Model No: Nautilus-2200

Issue: SLB22000510

Model Name: Ø2200mm Ocean Buoy

Bulletin: Product Improvement Instruction Revision Other: _____

Image:

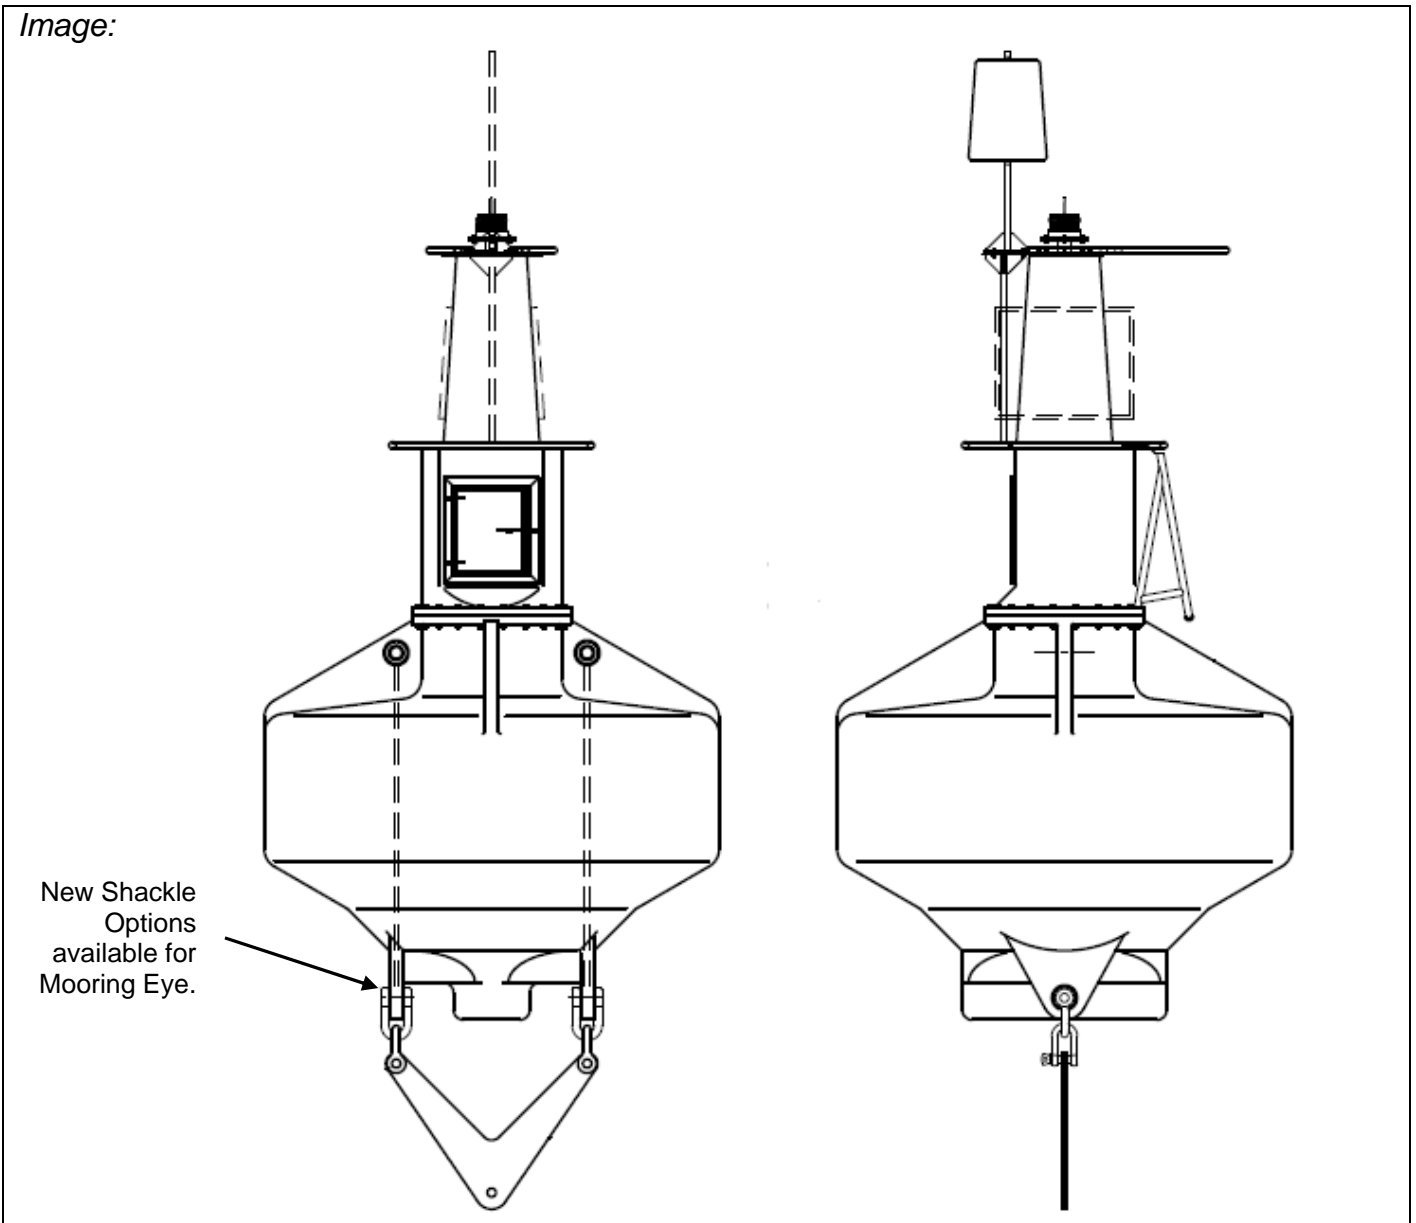
Description of Change	Reason for Change	Effective Date
More shackles available for Mooring Eye.	The Nautilus Ocean Buoy is currently fitted with Galvanised Grade M Ø38 mm Shackle. An alternative Ø38mm Shackle with Ø41mm Pin can be fitted to the Mooring Eye when fitting the Bridle. This gives the customer greater flexibility in their mooring options.	May 2010
